Order No. EA-12-049

August 28, 2014

Clinton Power Station, Unit 1
Facility Operating License No. NPF-62
NRC Docket No. 50-461

Subject: Third Six-Month Status Report in Response to March 12, 2012 Commission Order Modifying Licenses with Regard to Requirements for Mitigation Strategies for Beyond-Design-Basis External Events (Order Number EA-12-049)

Attachment 3 – Conceptual Sketches

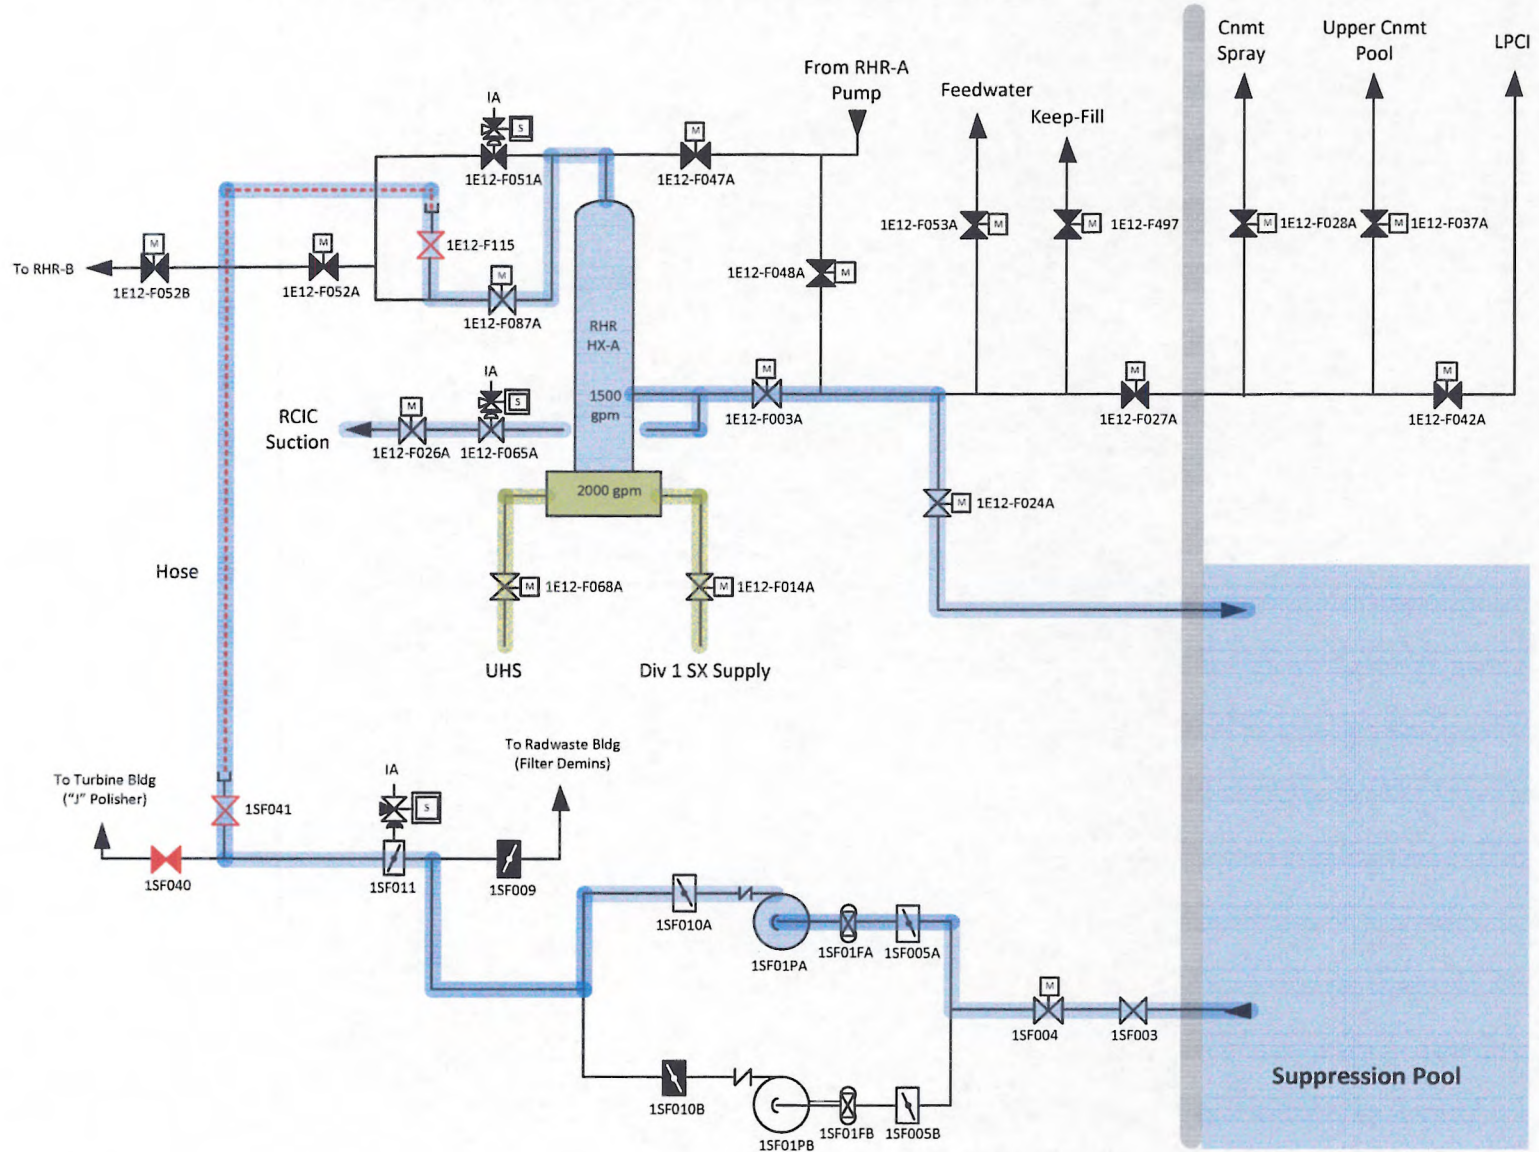
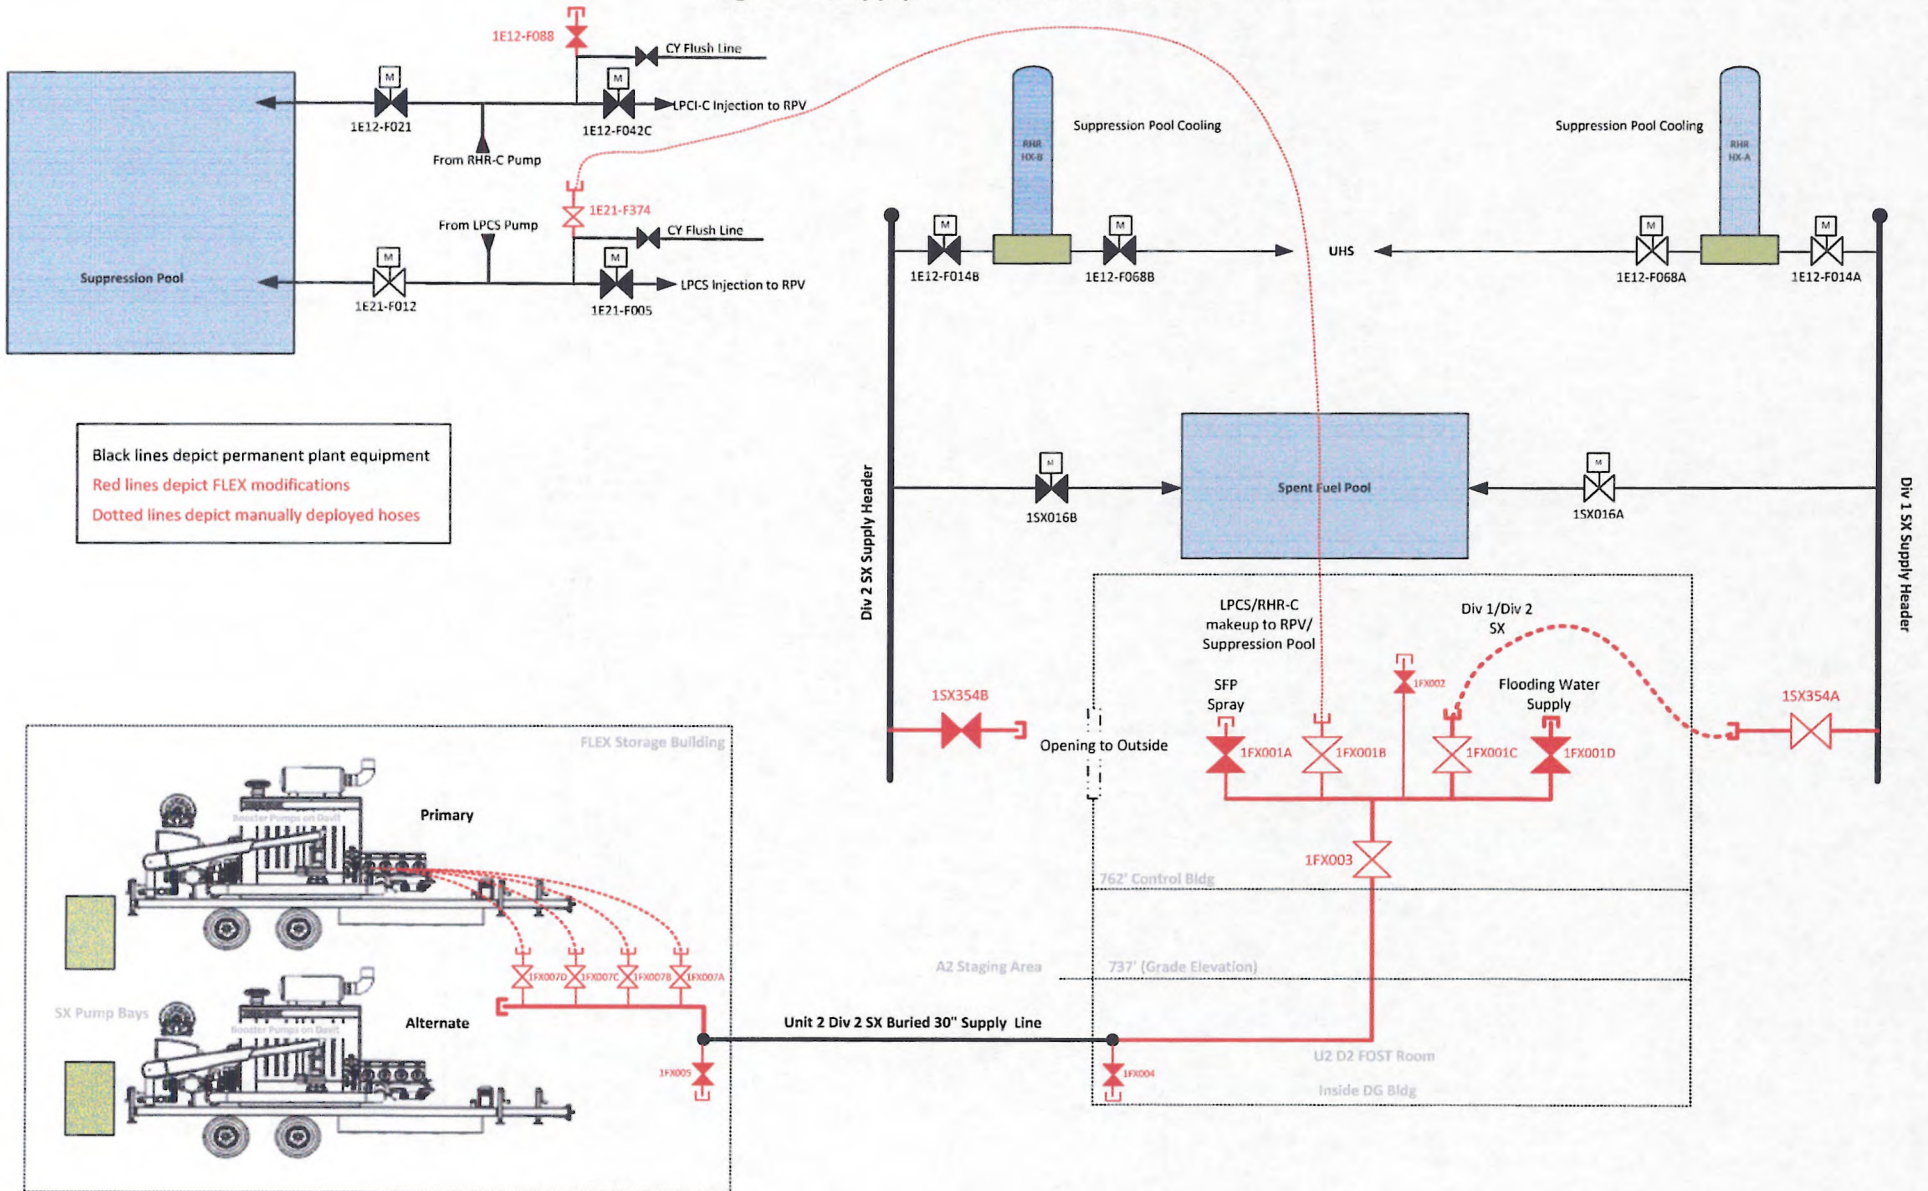
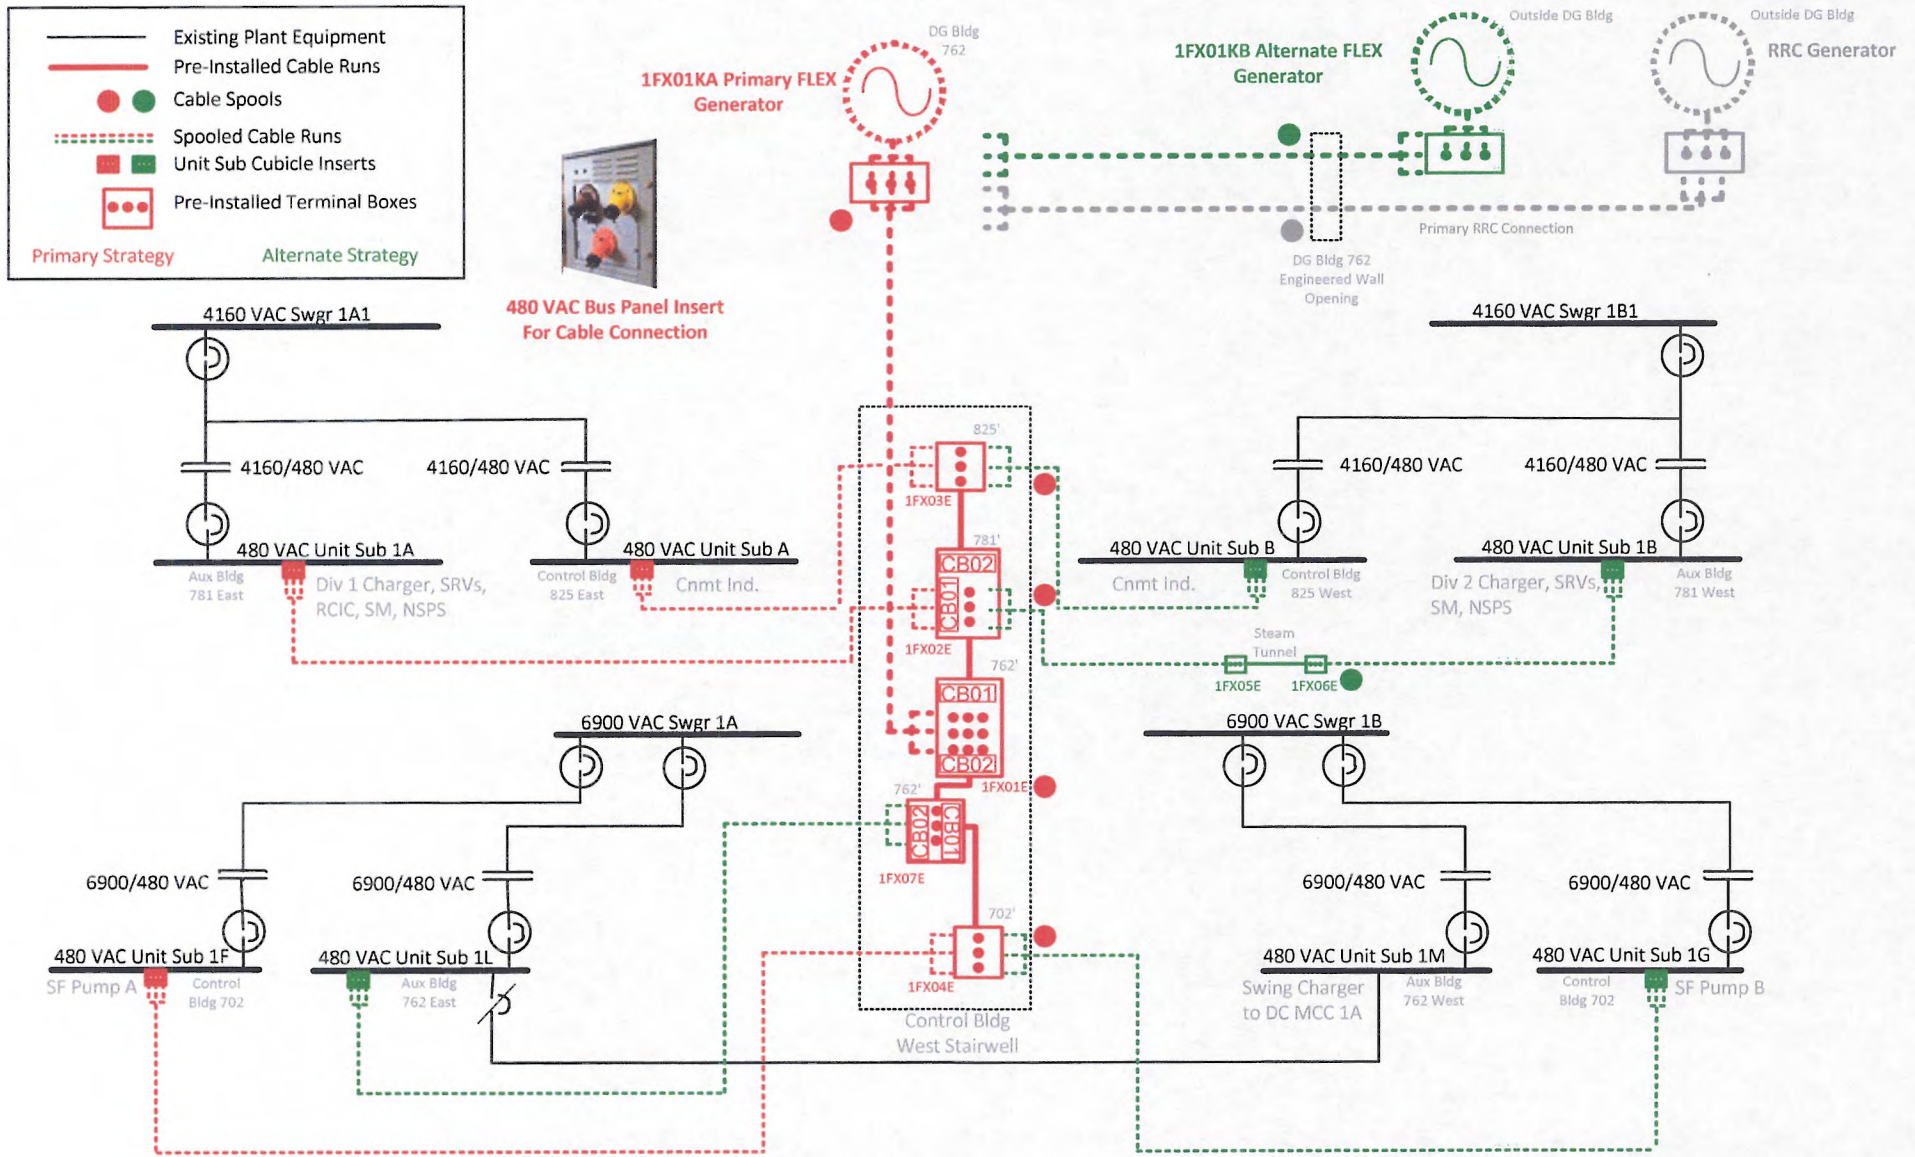
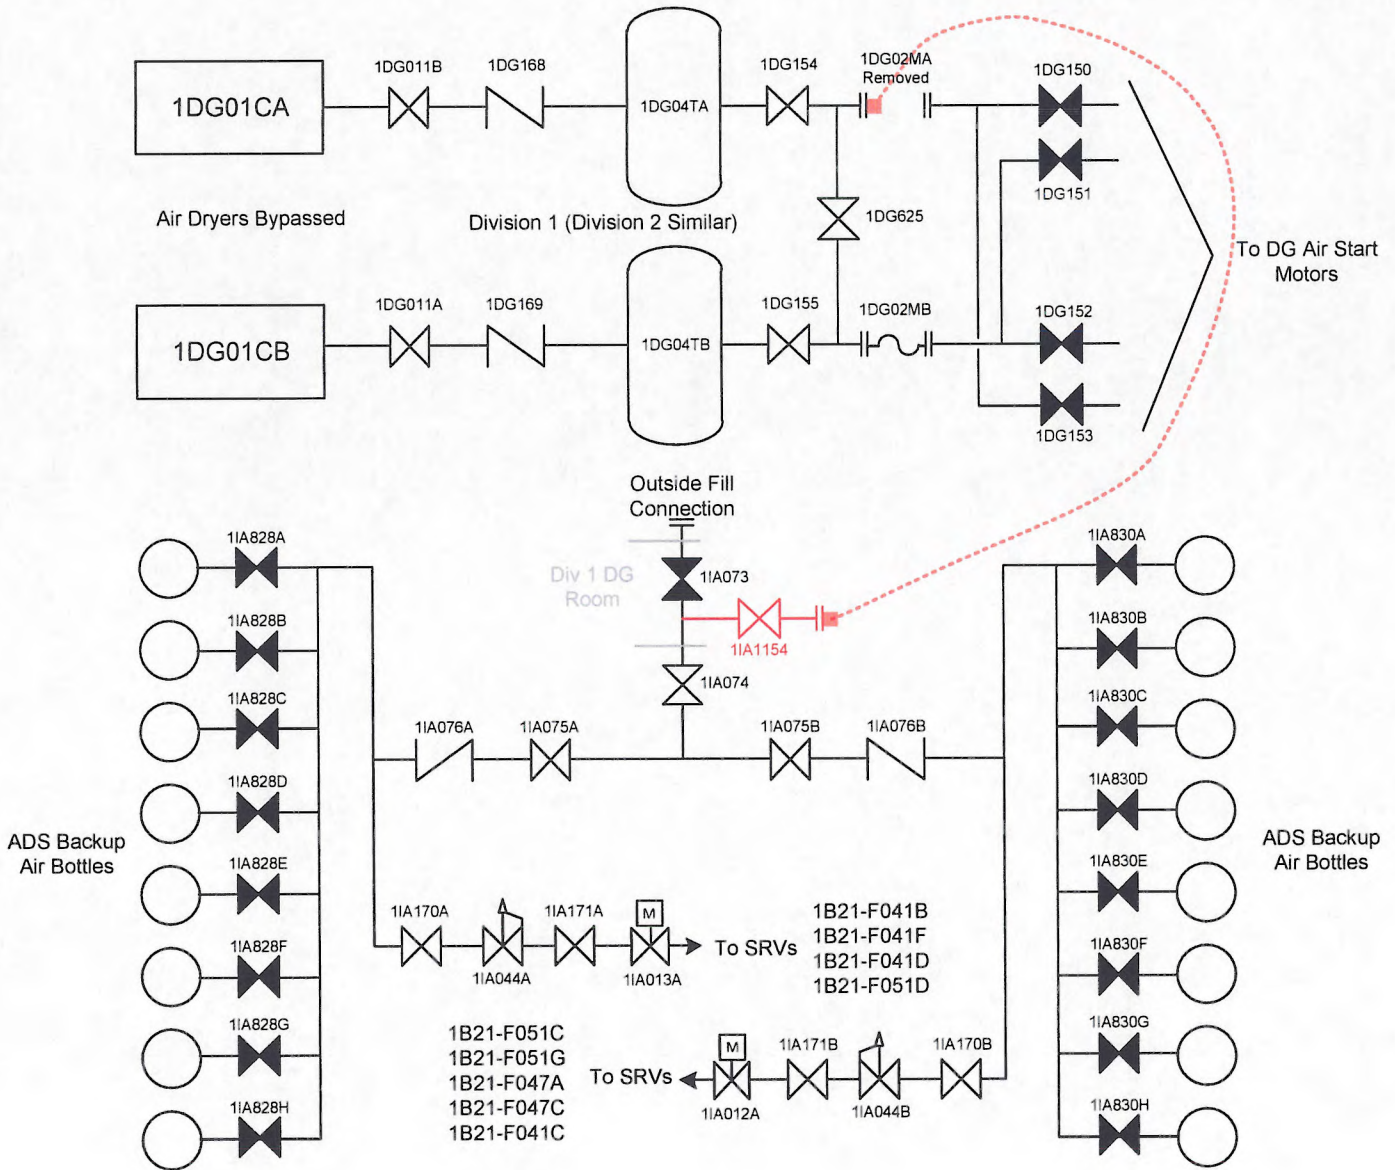
Reason for Change: Changes to deployment plan and system alignments required updated sketches. Color versions of the figures are available on the ePortal.

Updated Figures 2 through 5 to reflect advances in the ongoing engineering design.

MAAP Calculation of Collapsed RPV Water Level Inside the Shroud

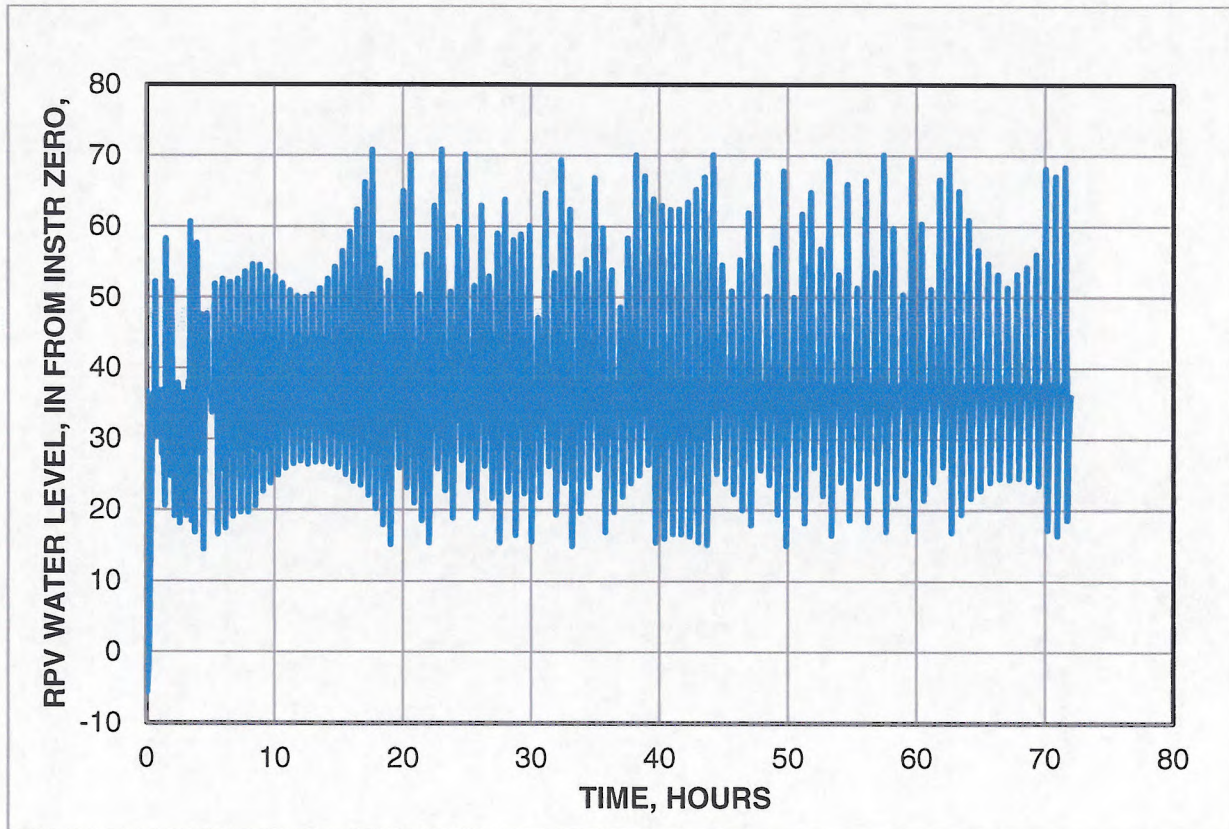
3.2.1.1.B	Collapsed level must remain above Top of Active Fuel and cool down rate must meet technical specifications.	<p>Information that validates the use of MAAP4 is contained in document <i>Forwarding of Clinton MAAP Justification for ELAP Analysis Acceptability</i> (Attachment 4) and is available on the ePortal.</p> <p>[Complete]</p>

For the representative MAAP run (Case 17), the collapsed RPV water level inside the shroud remains above TAF for the duration of the analysis. The plot below shows that the lowest RPV level, calculated by MAAP, is approximately -10" below instrument zero. (TAF is located at -162" relative to instrument zero⁽¹⁾.) As shown in the following plot, the collapsed RPV water level remains at least 12' above TAF for the duration of the analysis.

The figure below illustrates the Clinton containment nodalization along with an identification of containment flow junctions.

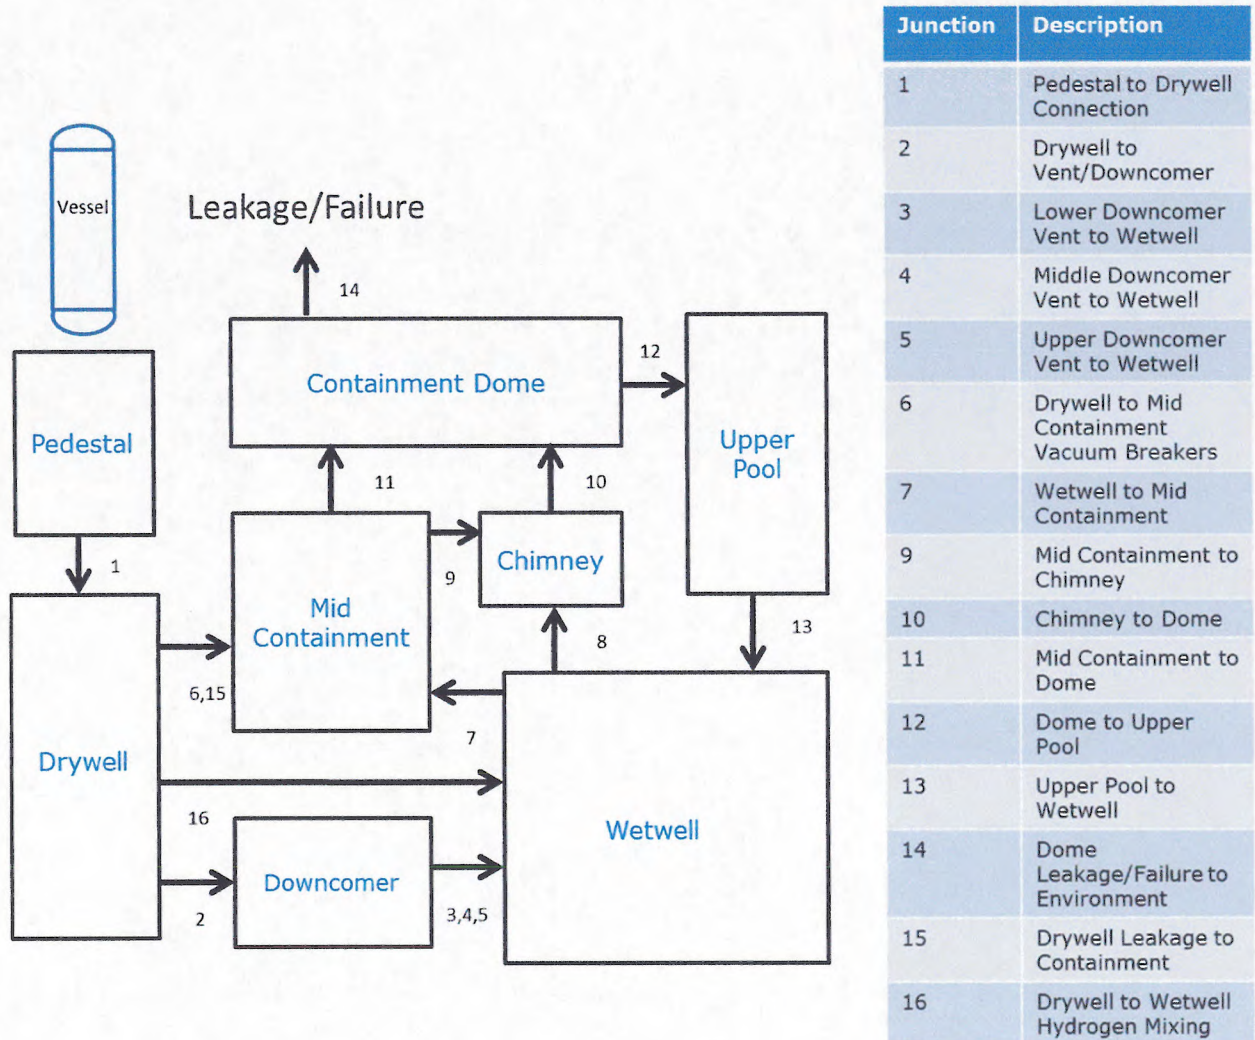
- (4) *In using MAAP4, the licensee must identify and justify the subset of key modeling parameters cited from Tables 4-1 through 4-6 of the "MAAP4 Application Guidance, Desktop Reference for Using MAAP4 Software, Revision 2" (Electric Power Research Institute Report 1020236). This should include response at a plant-specific level regarding specific coding options and parameter choices for key models that would be expected to substantially affect the ELAP analysis performed for that licensee's plant. Although some suggested key phenomena are identified below, other parameters considered important in the simulation of the ELAP event by the vendor / licensee should also be included.*

- a. The reactor vessel nodalization is fixed by the MAAP code and cannot be altered by the user, with the exception of the detailed core nodalization. The Clinton MAAP 4.0.5 parameter file divides the core region into 5 equal volume radial regions (See NCHAN) and 13 axial regions (See NAXNOD). The axial nodalization represents 10 equal-sized fueled nodes (see NROWS), 1 unfueled node at the top (see NNFT), and 2 unfueled nodes at the bottom (see NNFB). The figure below, taken from the MAAP Users Manual, illustrates the vessel nodalization scheme.
